**Planning Commission  
Staff Report**

April 9, 2014  
Item 6.a.

- SUBJECT:** PUD-98 and P13-2518
- APPLICANT:** Keith Henderson for CarMax Auto Superstores
- PROPERTY OWNER:** Alameda County Surplus Property Authority

- PURPOSE:** Applications for PUD Development Plan and Sign Design Review to construct an automobile dealership consisting of an approximately 11,783-square-foot sales and presentation building, an approximately 45,000-square-foot service building, an approximately 3,930-square-foot quality control building and non-public car wash, vehicle sales display area, project signage, and related site improvements on approximately 19.66 acres of the Auto Mall site at Staples Ranch.

**FIGURE 3:** Proposed Site Plan

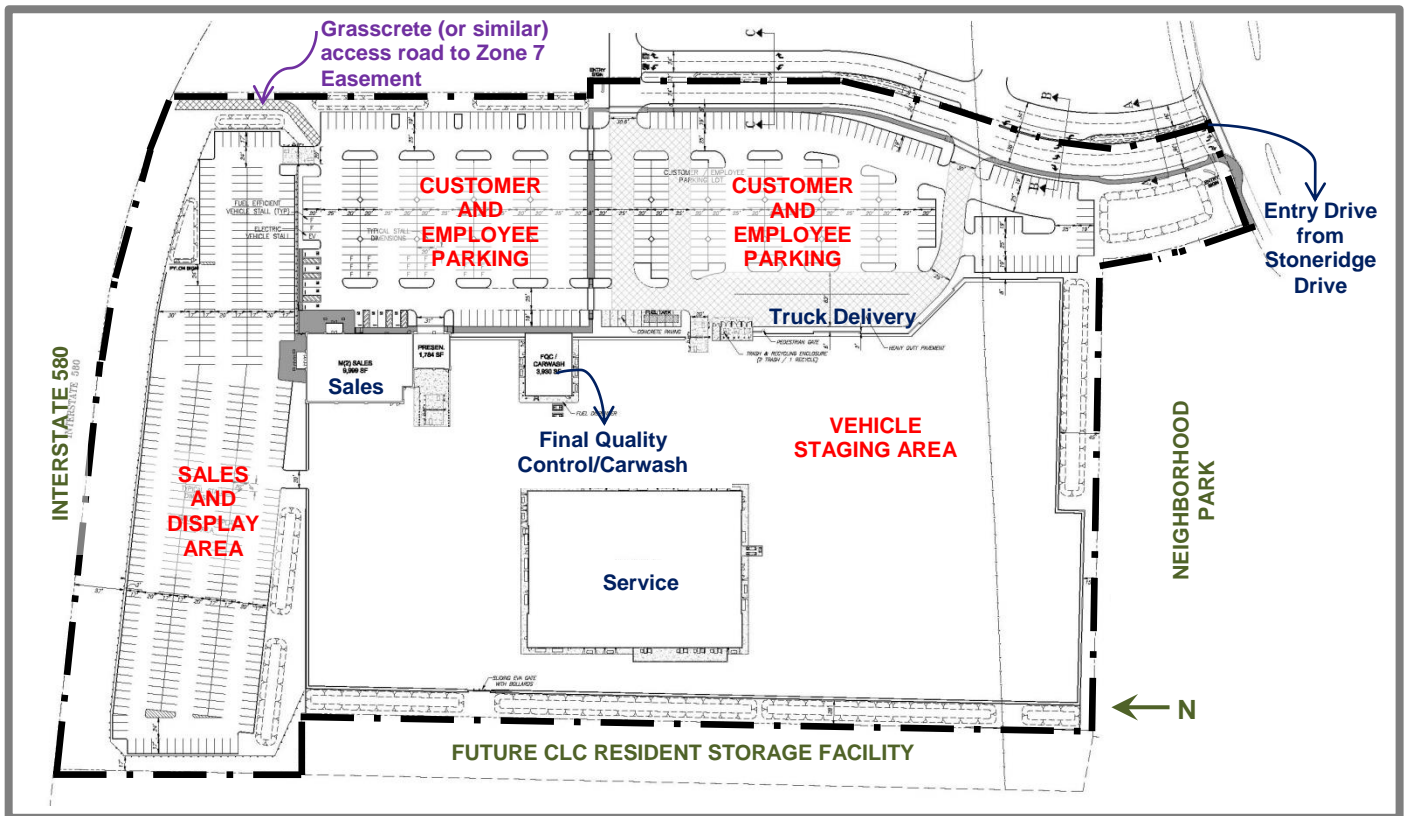
The site plan has been designed to allow access to the site via an entry road from Stoneridge Drive. The entry drive has two lanes to enter the project site (or adjacent future development) and three lanes for exiting. A left turn pocket allows access to the project site's southern driveway. The access drive continues further north and ends at a proposed stop sign intersection where in-coming visitors would make a left turn into the subject site (or a right-turn into the future auto dealer's site). Generally, staff finds the site plan acceptable.

Parking on the site is divided into three areas: customer/employee, display area, and vehicle staging area. Parking stalls and drive aisles within the customer/employee meet or exceed minimum dimensions required by the PMC, whereas parking stalls and drive aisles within the display area are substandard, but are only accessible by employees. A total of 431 spaces are proposed within the customer/employee parking lot. Staff believes this is more than adequate parking for customers and employees.

As mentioned previously, circulation on the site is facilitated by two driveways from the entry drive. Drive aisles in the customer/employee parking lot meet the minimum standards in the PMC. Areas not accessible to customers include the display area and the vehicle staging area. Since only employees will be able to drive cars within these areas, staff finds the circulation acceptable.

**FIGURE 8:** Proposed Landscaping Plan

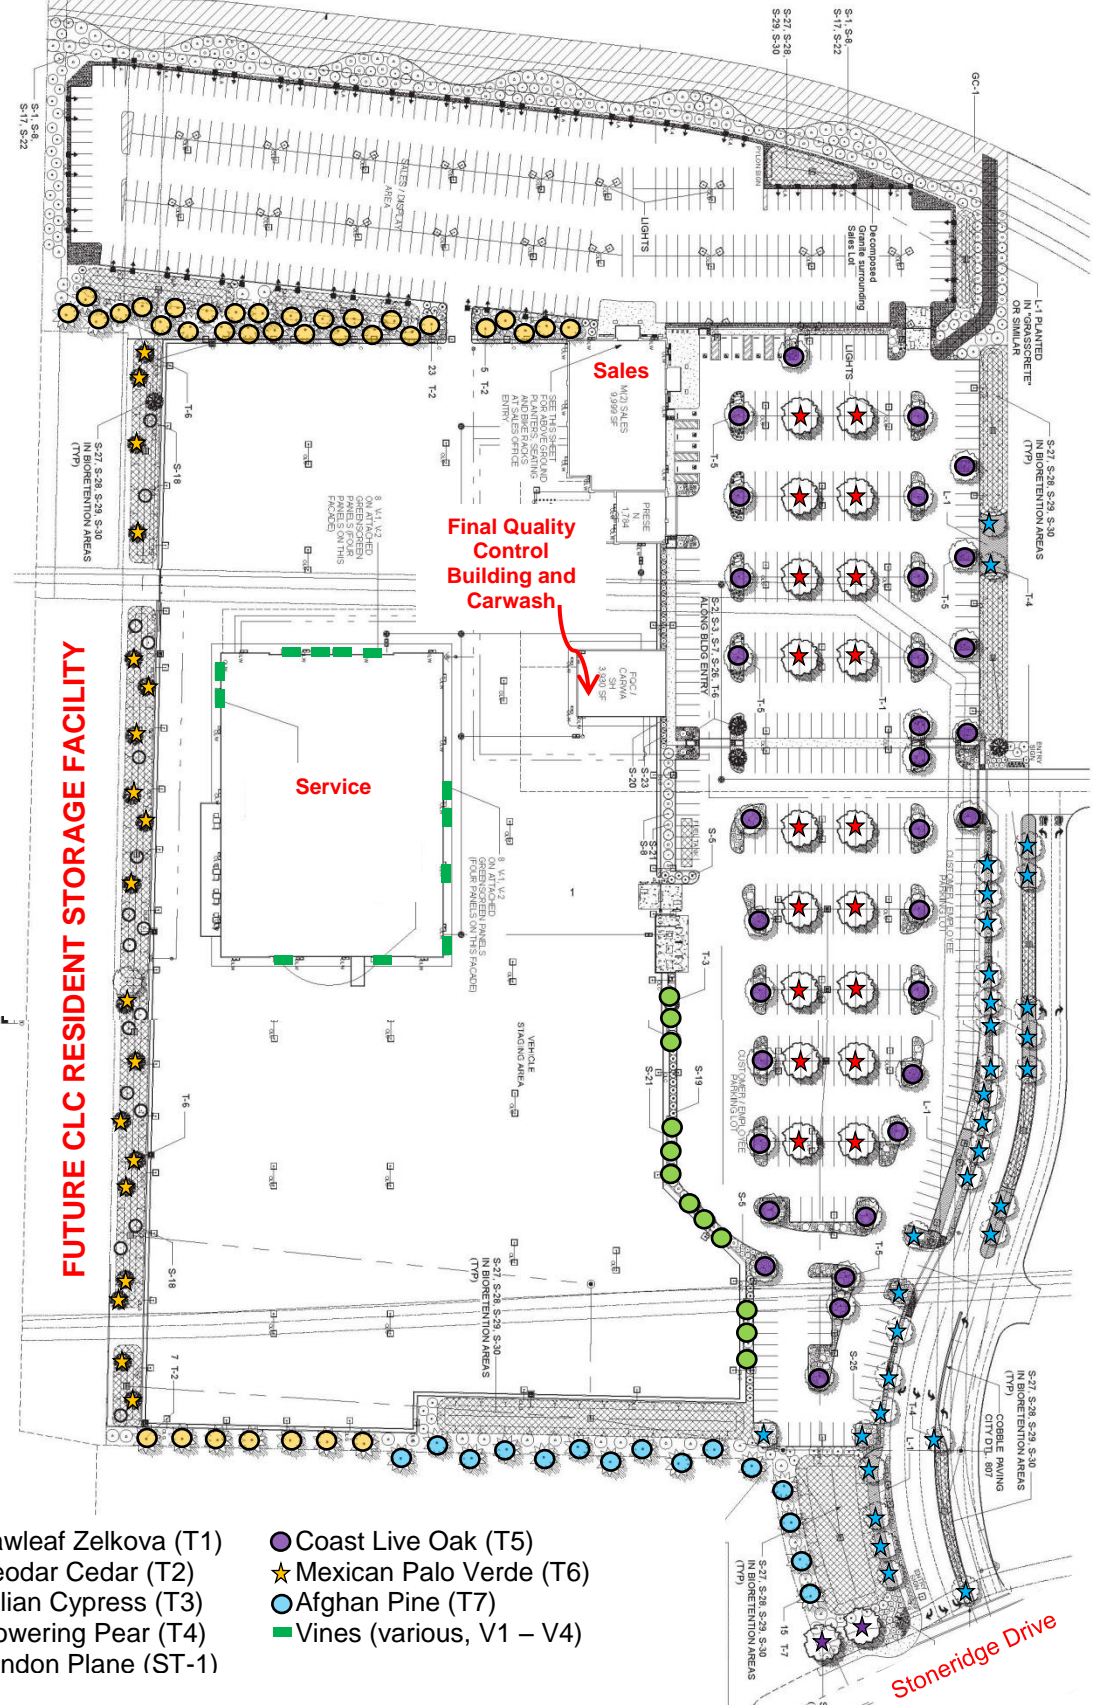
Since there are no trees on the subject site, none will be removed. The landscaping plans provided as part of Exhibit B include a preliminary planting plan that incorporates both evergreen and deciduous tree species. Various types of shrubs and groundcover are located within bioretention areas and parking lot planter islands. According to the preliminary plant schedule, all trees are proposed to be 24-inch box size. Since the February 12, 2014, Workshop with the Planning Commission, the applicant has increased the number of Deodar cedar trees located within the planter area directly north of the vehicle staging area to further screen the service building, modified the tree species in the landscape planter diamonds to Sawleaf Zelkova instead of Arizona Ash, and identified the two street trees shown as London Plane. Staff believes that the species, quantities, and sizes of the proposed landscaping for the site are adequate.

**FIGURE 11:** Proposed Pylon Sign and Monument Sign at Entry Drive

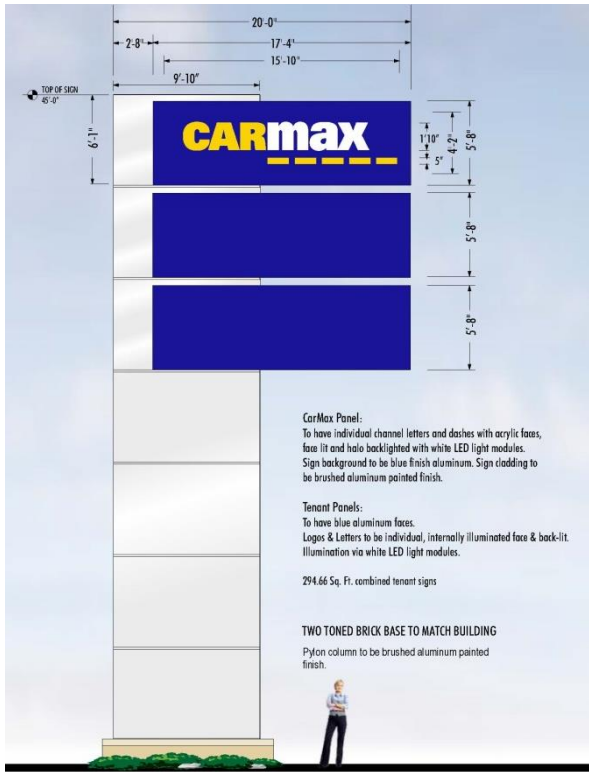
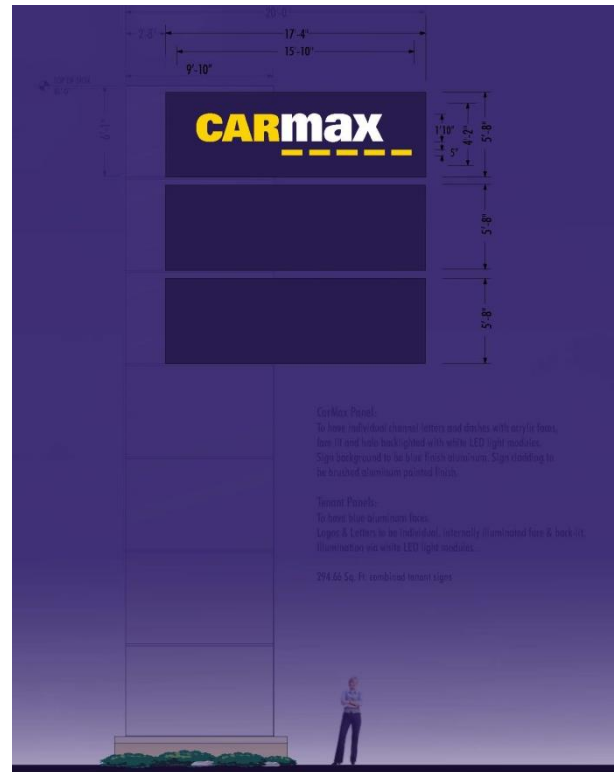
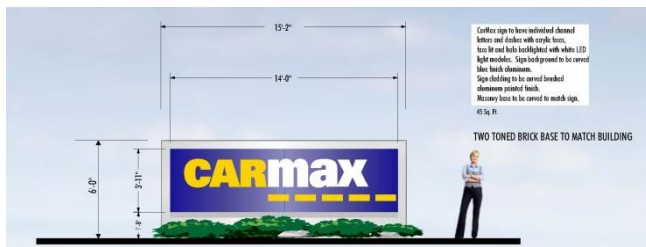
Two ground-mounted signs are part of the Exhibit B plans for the Planning Commission's review: the freeway-oriented pylon sign and the monument sign at the entry drive. Given the conformance to the pylon sign's height maximum in the Specific Plan Amendment, staff is supportive of the sign as long as only one type of illumination is used, the background of the cabinets remains opaque (such that only sign copy or logos illuminate), and future dealers submit their cabinet proposal subject to review by the Director of Community Development prior to permit issuance. Staff also acknowledges that while the applicant has shown the future cabinets to be blue on Exhibit B plans, future auto dealers will likely want to incorporate their own corporate color for the sign background, and thus the cabinets will not have the same blue background as depicted. Overall, staff finds both the pylon sign and the proposed monument sign to be acceptable.
